Inspection Report

Property Address:
Sample Street
Ashgrove QLD 4060

Pool Safety Inspection

3687143

3) Fence Height ground to top of fence - 1200mm

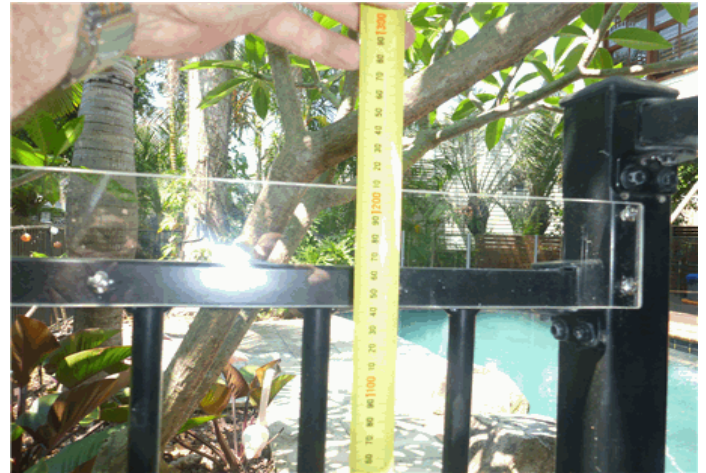
Fence height was checked and height was OK, after corrective actions were taken to obtain correct height on a fence panel on the northern side of the fence gate.

1. Removed table and chairs from the NCZ (No Climb Zone)
2. Re-positioned large pot plants to be clear of the NCZ and Additional Clear Area
3. Re-positioned bracing rope on the Frangipani tree to remove from the 300mm Inside Clear Area
4. Installed a sheet of Perspex to the aluminium fence north of the gate to attain 1200mm height on this section
4. Replaced and installed CPR Signage

8) Identify Additional Clear Area 1200mm to NCZ arc

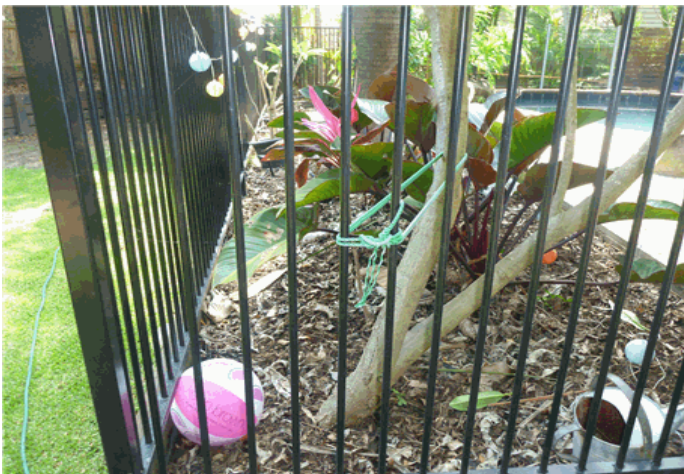
Additional Clear Area was checked and found compliant, after removal of some Pot Plants from the Area.
